**MUNICIPAL SERVICES CENTER, COUNCIL CHAMBER
3600 TREMONT ROAD**

BZAP Meeting Date: September 6, 2023

Subject: 2096 Jervis Road (VAR-40-23) - To allow the construction of a second-story addition atop the existing footprint (with a slight expansion) that encroaches 1.7 feet (west) and 1.1 feet (east) into the eight-foot minimum side yard setbacks, resulting in a side yard sum setback of 13.2 feet, in lieu of the 16-foot minimum. The height of the house also exceeds the neighborhood compatibility standards by eight inches.

Subject: 3230 Northwest Boulevard (DEV-03-23) - Review of a Major Site Plan application to allow for the demolition of a vacant two-story office building and the construction of a two-story child day care center for The Barrington School of Kingsdale.

L-1

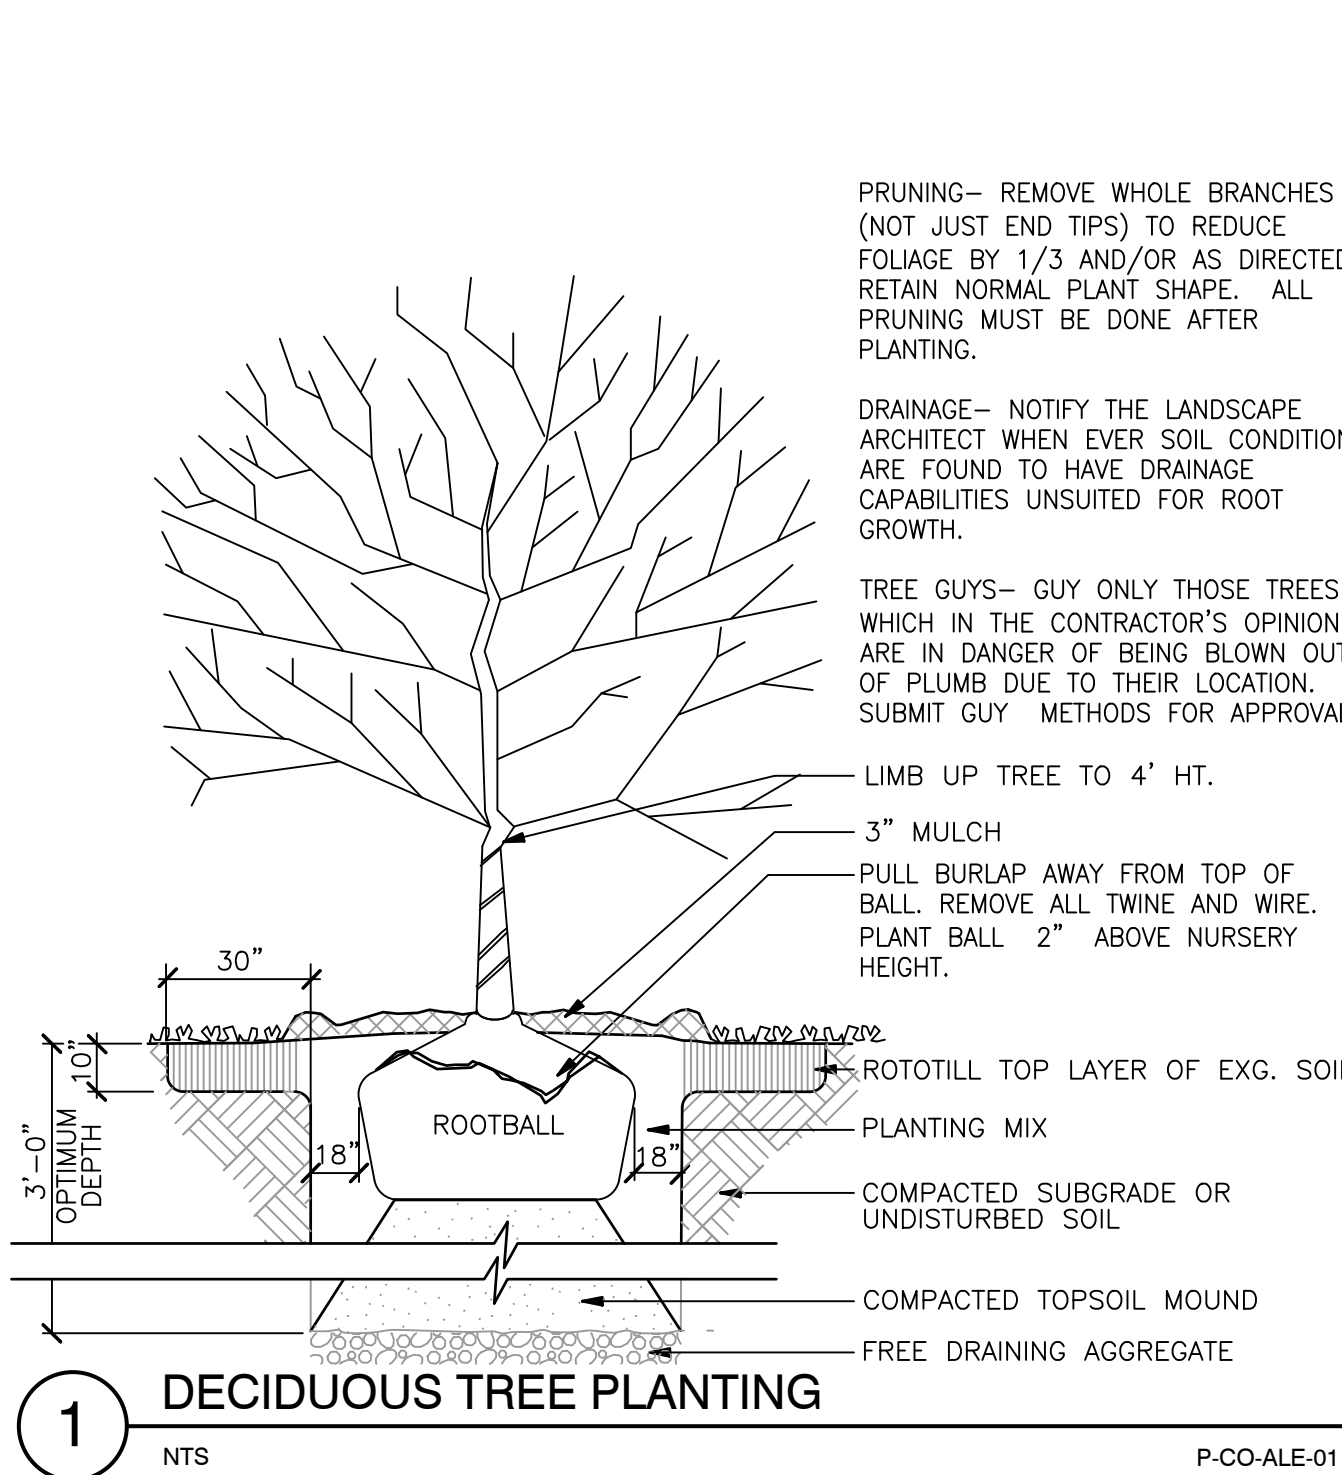
The proposed landscape plan includes no changes to the existing landscaping on the north side of the property, as it is in fair condition and is off-site. [The applicant has tried to coordinate efforts with the bank, but has not received any response.] Along the east property line, the existing off-site six-foot tall wood privacy fence near the east property line will remain. The existing on-site mature landscaping will be retained and supplemented with new plant materials. The proposal retains the five existing street trees located within Northwest Boulevard right-of-way, while none are shown along Trentwood Road. Tree protection measures will be utilized. The City recently constructed a sidewalk along this stretch, aware that there would be limited room for street trees. Foundation plantings are shown along the building per code. Overall site development coverage is 78 percent, two percent below the maximum limit and well below existing site conditions. This plan has not yet been approved by the City Forester.

- 8) **Landscape Plan** – The City Forester is presently reviewing the submitted landscape plan and will offer comments when available. For added protection and security, please consider additional brick columns along the playground fencing.

1. *That a final landscape plan be reviewed and approved by the City Forester, which includes tree protection measures of at least 10 feet and retention/enhancement of the eastern landscape buffer;*
2. *That the final design of access and on-street parking be reviewed and approved by the City Engineer;*
3. *That the parking agreement for six off-site parking spaces be maintained unless otherwise approved by the Community Development Director;*
4. *That no bells or horns be used on the exterior of the building; and*
5. *That the proposed building be eligible for LEED® certification, with a scorecard submitted with the Building Permit application.*
